54 Canal Street aka 9 Orchard Street

Amend the originally approved submission to include: restoration of domed spire to be GFRC & GFRP combination, increase approved roof deck height

(in compliance with ZR 74-711), modify approved balustrade design to incorporate code requirements regarding railing, add marquee at Orchard Street entrance, increasing dunnage height at roof

Historic Restoration and Preservation - Amendments

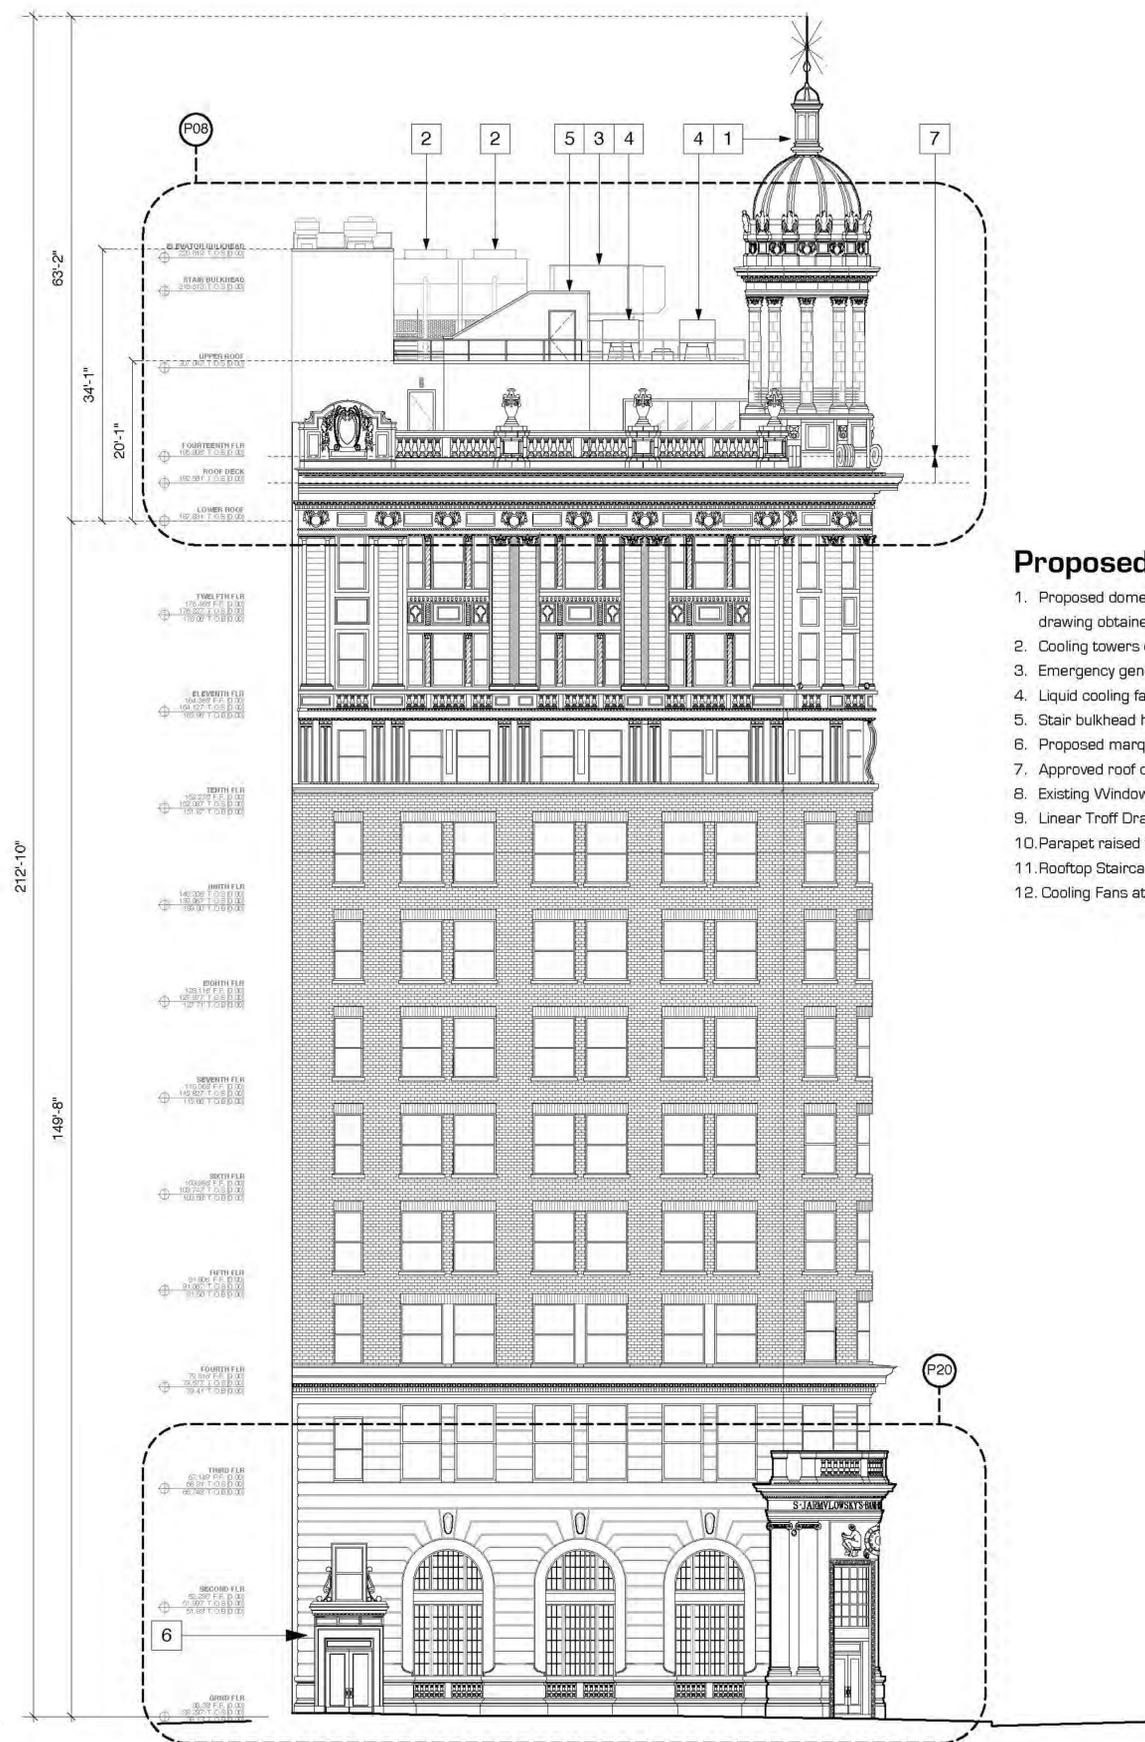
1. Proposed domed spire to match original historic domed spire. Details to be generated from original 1912 Rouse & Goldstone drawing obtained from Department Of Buildings and photographic documentation obtained from the New York Municipal Archives

2. Cooling towers on the roof have been raised approx. 10"
3. Emergency generator on the roof has been raised 10"
4. Liquid cooling fans on the roof have been raised 4"

5. Stair bulkhead has been flipped
6. Proposed marquee to be installed at Orchard Street entrance
7. Approved roof deck proposed to be raised an additional 3'-1" Pursuant to the zoning text ZR 74-711

8. Existing Windows to be converted to doorway openings to allow access to Roof Deck of New Construction at 60 Canal Street
9. Linear Troff Drains to be installed at the perimeter of the Roof Deck parallel to the existing parapet

10. Parapet raised to meet 42" minimum height above Roof Deck required by the 2008 New York City Building Code
11. Rooftop Staircase removed to correspond with amendment #7

12. Cooling Fans at Roof Re-arranged

East Building Elevation - Amendments

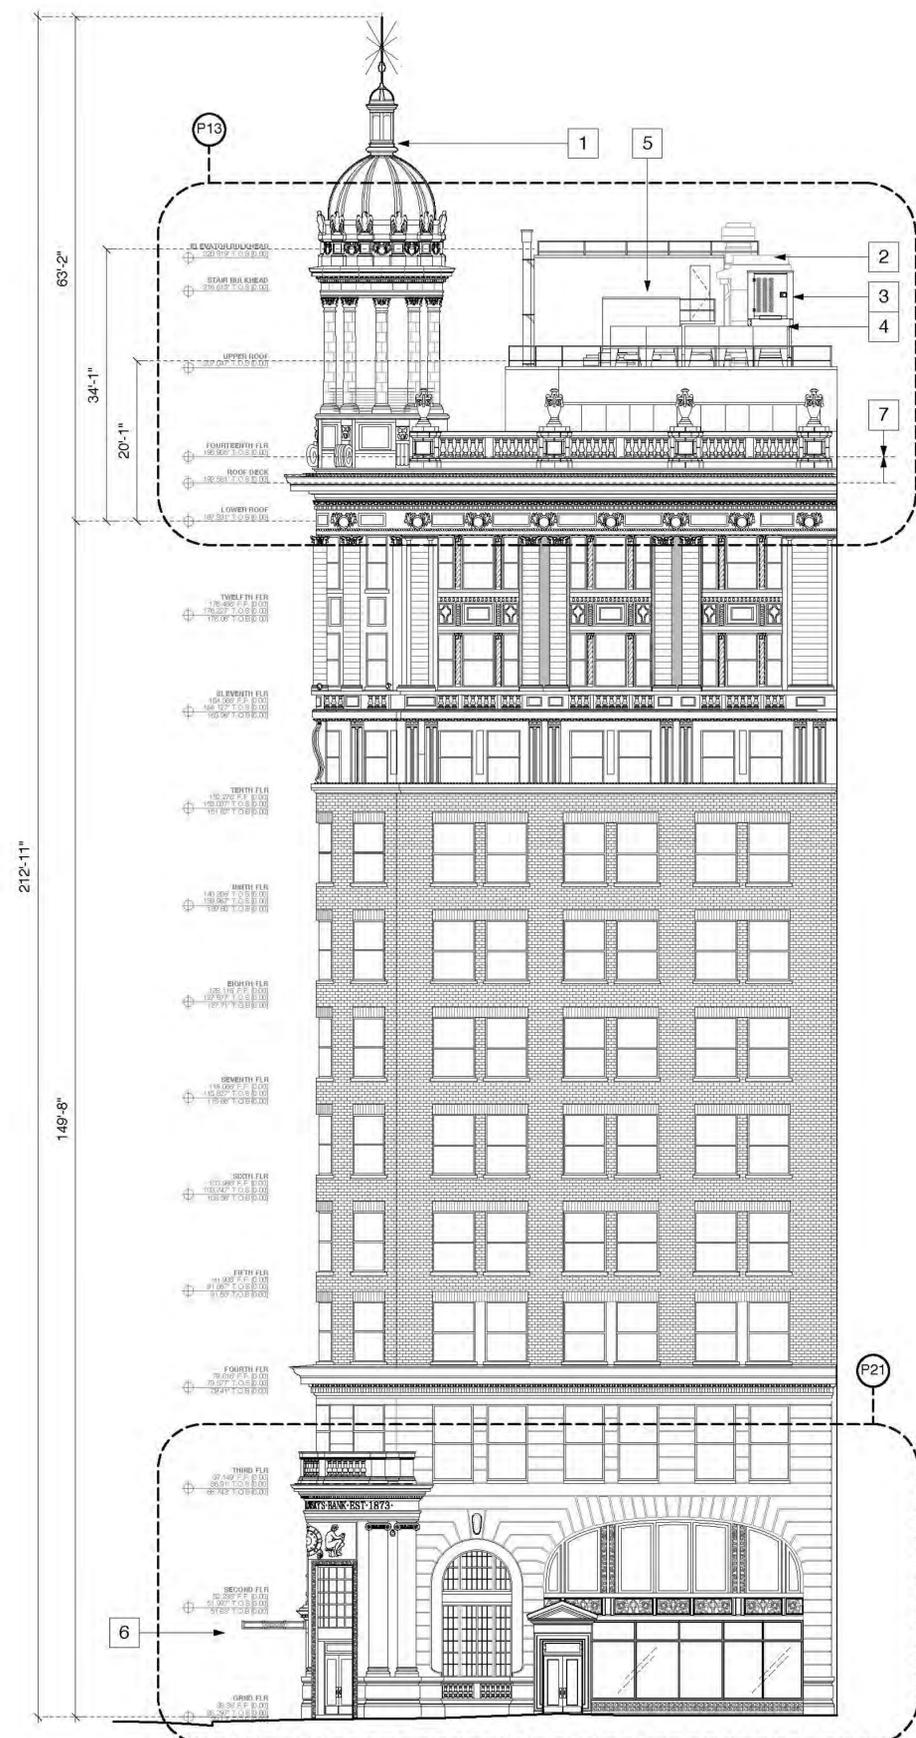
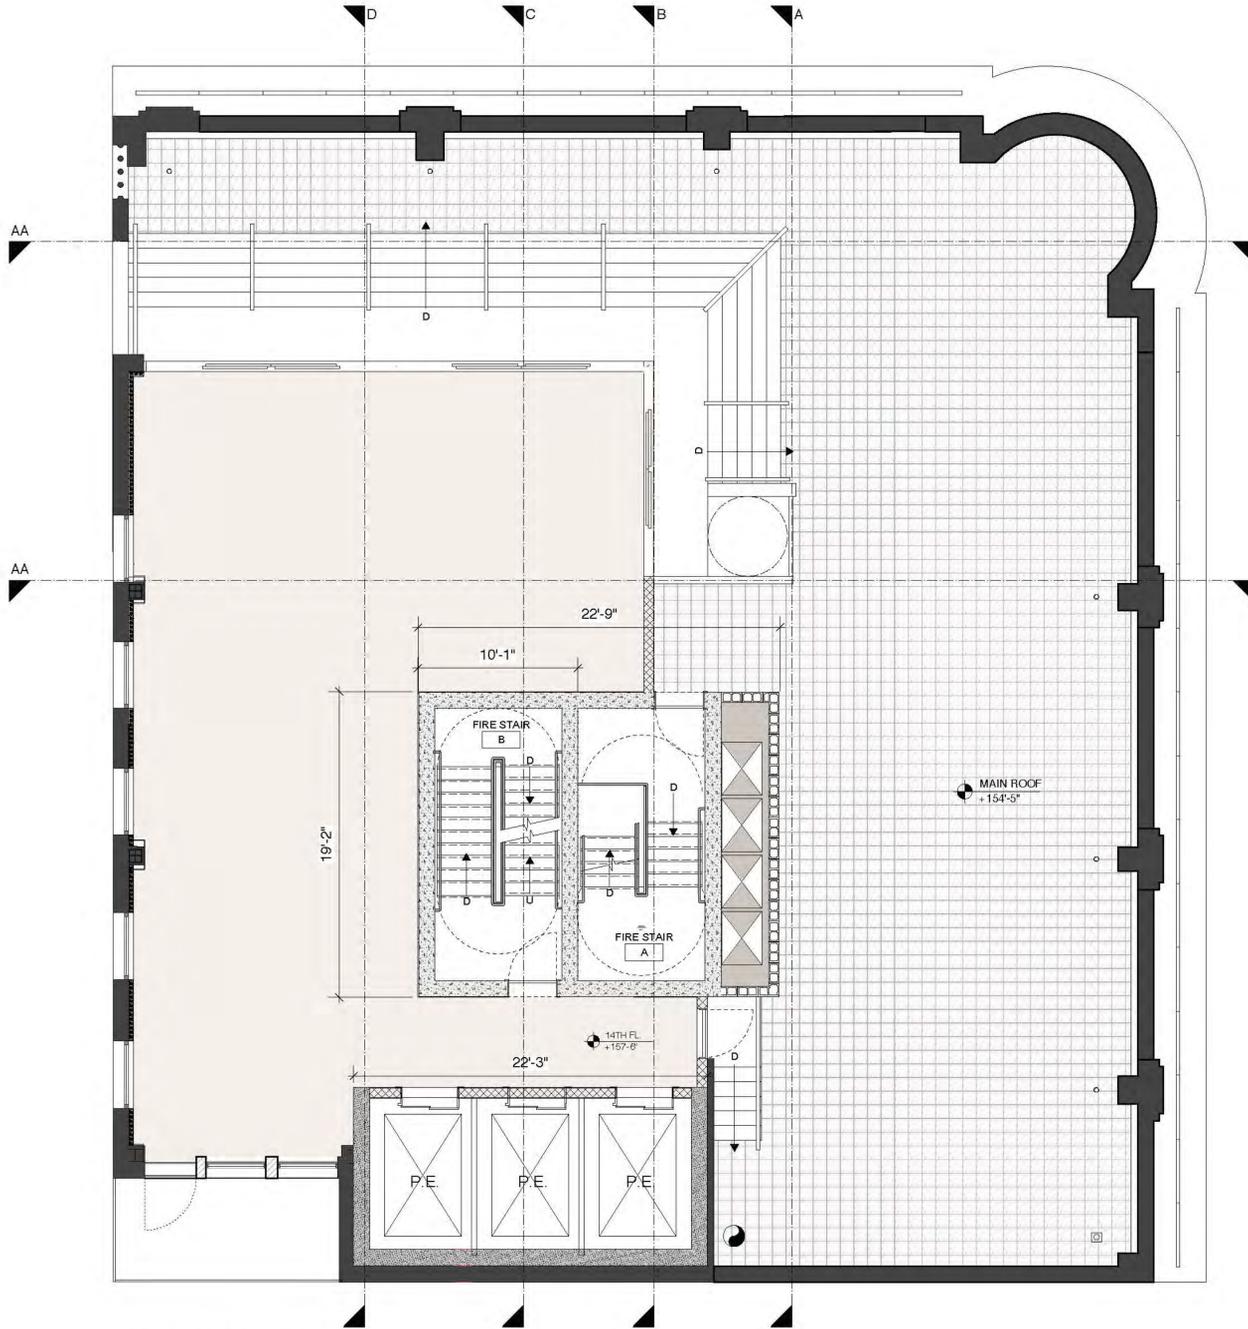
1. Proposed domed spire to match original historic domed spire. Details to be generated from original 1912 Rouse & Goldstone drawing obtained from Department Of Buildings and photographic documentation obtained from the New York Municipal Archives

2. Cooling towers on the roof have been raised approx. 10"
3. Emergency generator on the roof has been raised 10"
4. Liquid cooling fans on the roof have been raised 4"

5. Stair bulkhead has been flipped
6. Proposed marquee to be installed at Orchard Street entrance
7. Approved roof deck proposed to be raised an additional 3'-1" Pursuant to the zoning text ZR 74-711

8. Existing Windows to be converted to doorway openings to allow access to Roof Deck of New Construction at 60 Canal Street
9. Linear Troff Drains to be installed at the perimeter of the Roof Deck parallel to the existing parapet

10. Parapet raised to meet 42" minimum height above Roof Deck required by the 2008 New York City Building Code
11. Rooftop Staircase removed to correspond with amendment #7

12. Cooling Fans at Roof Re-arranged

Jarmulowsky Bank Building Roof Deck Plan - Amendments

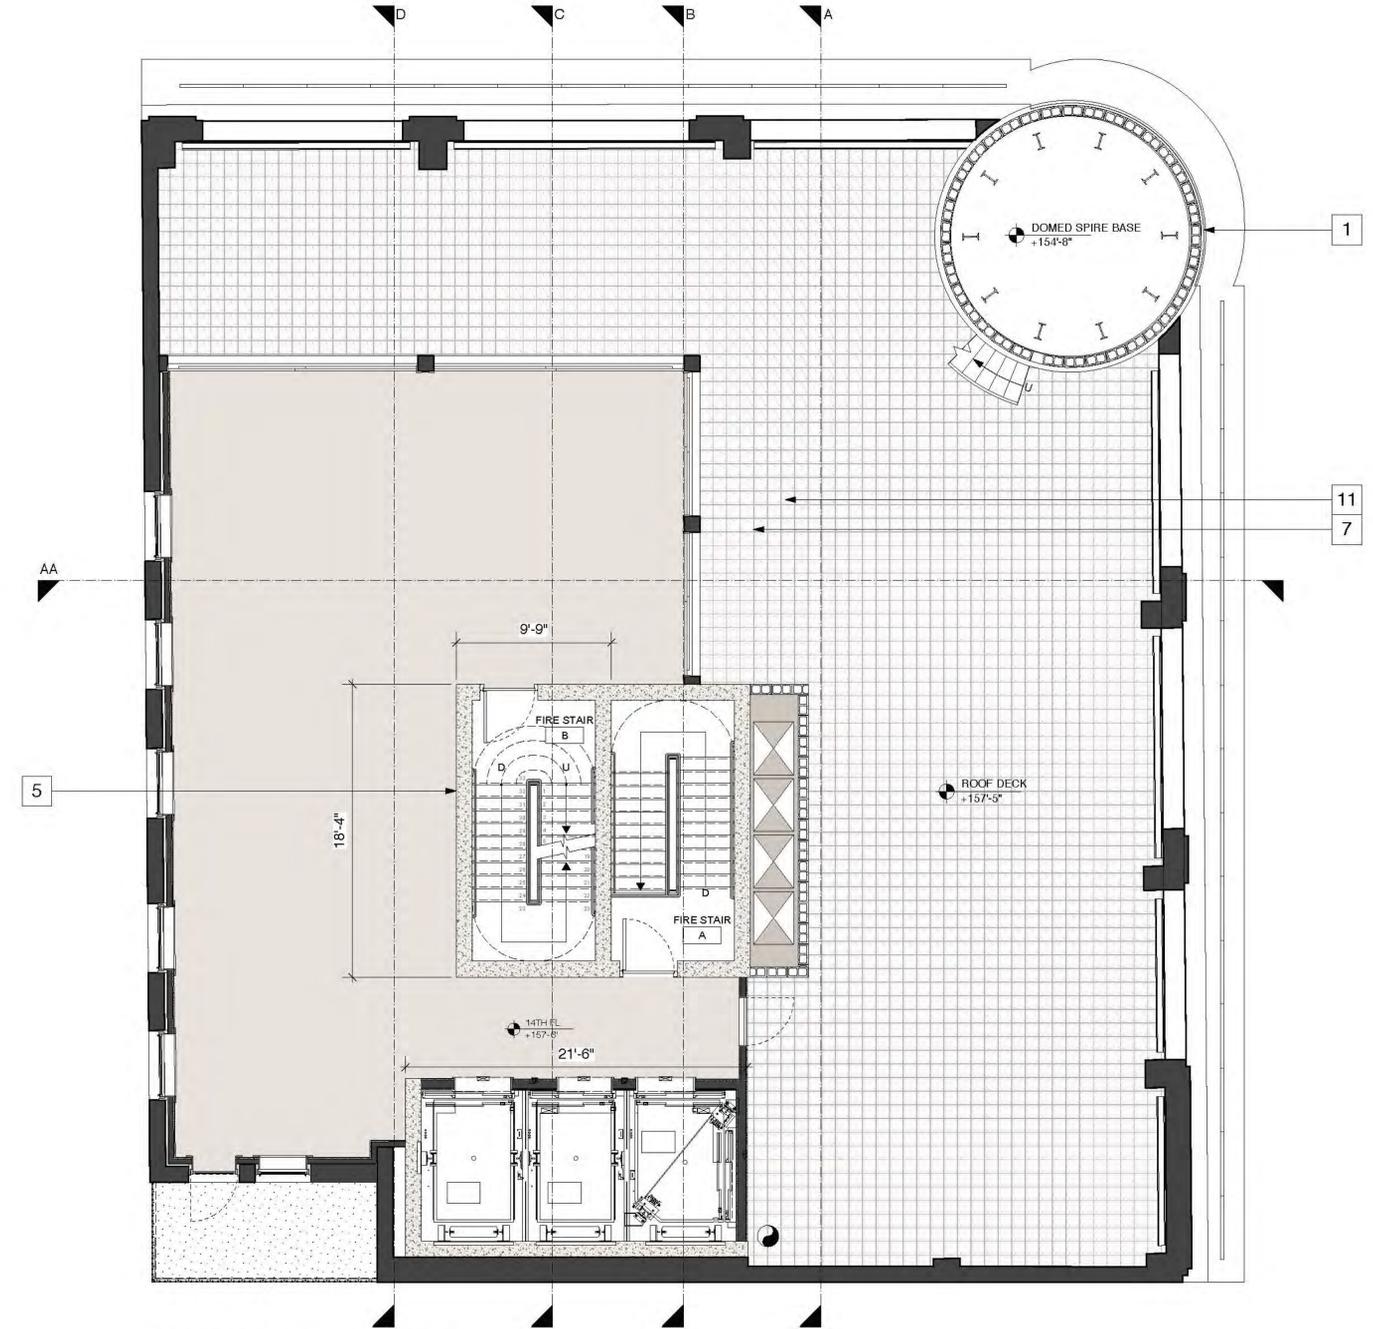
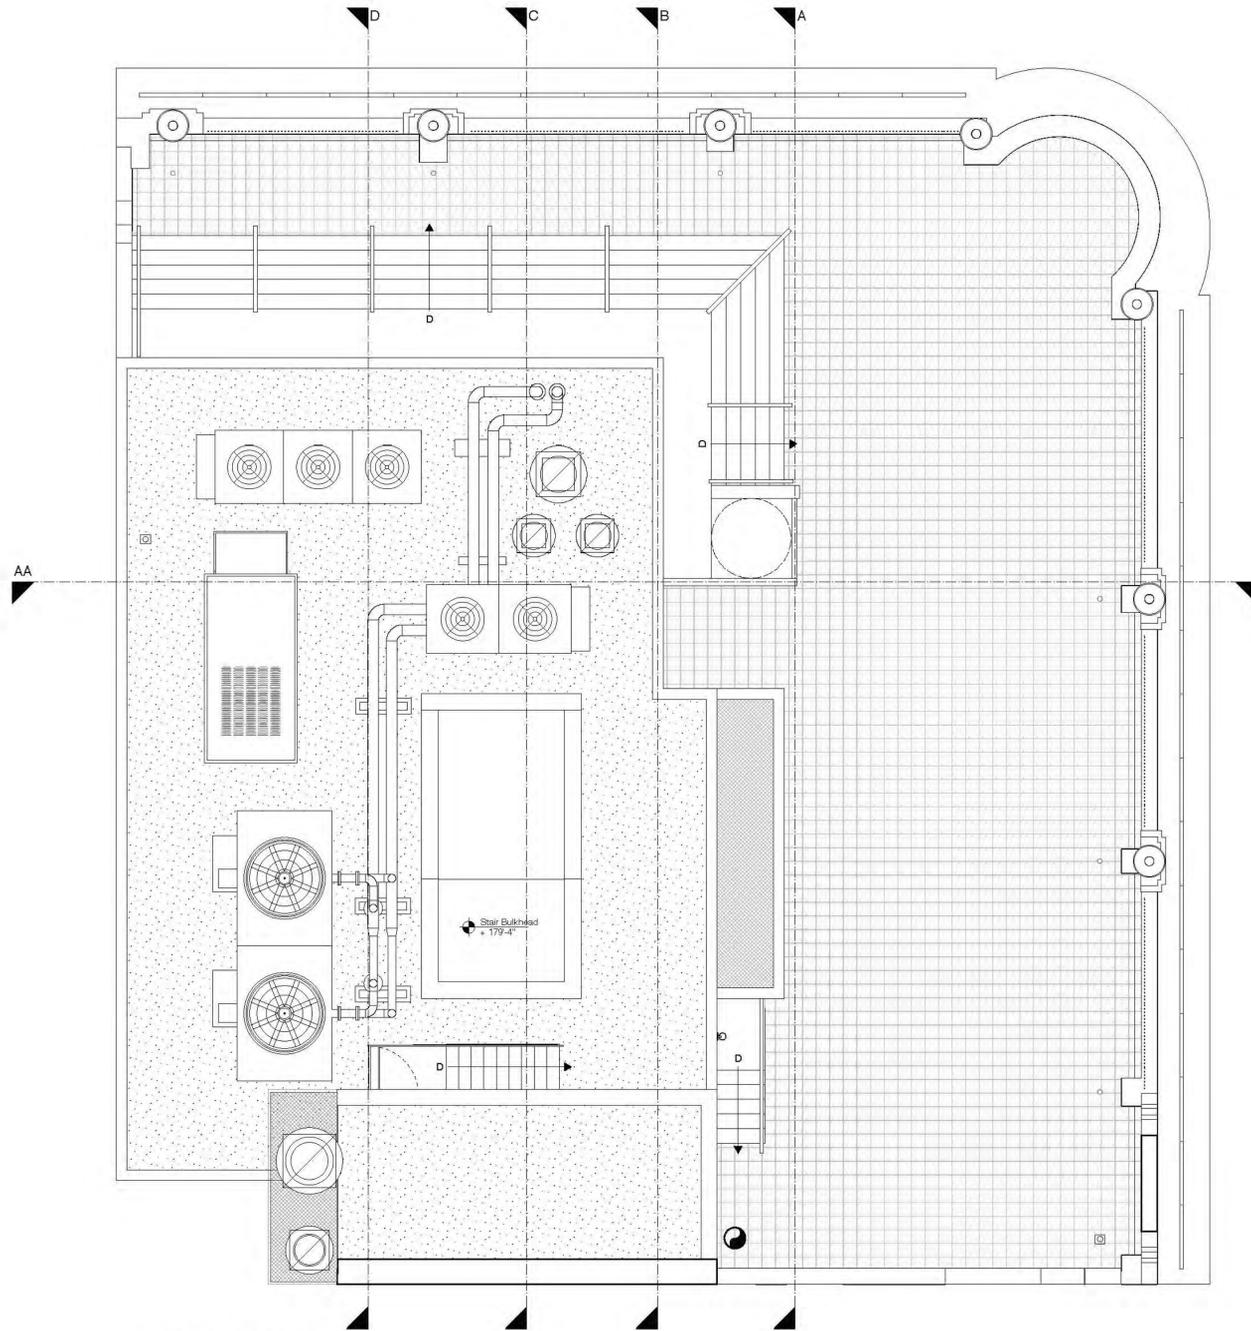
1. Proposed domed spire to match original historic domed spire. Details to be generated from original 1912 Rouse & Goldstone drawing obtained from Department Of Buildings and photographic documentation obtained from the New York Municipal Archives

2. Cooling towers on the roof have been raised approx. 10"
3. Emergency generator on the roof has been raised 10"
4. Liquid cooling fans on the roof have been raised 4"

5. Stair bulkhead has been flipped
6. Proposed marquee to be installed at Orchard Street entrance
7. Approved roof deck proposed to be raised an additional 3'-1" Pursuant to the zoning text ZR 74-711

8. Existing Windows to be converted to doorway openings to allow access to Roof Deck of New Construction at 60 Canal Street
9. Linear Troff Drains to be installed at the perimeter of the Roof Deck parallel to the existing parapet

10. Parapet raised to meet 42" minimum height above Roof Deck required by the 2008 New York City Building Code
11. Rooftop Staircase removed to correspond with amendment #7

12. Cooling Fans at Roof Re-arranged
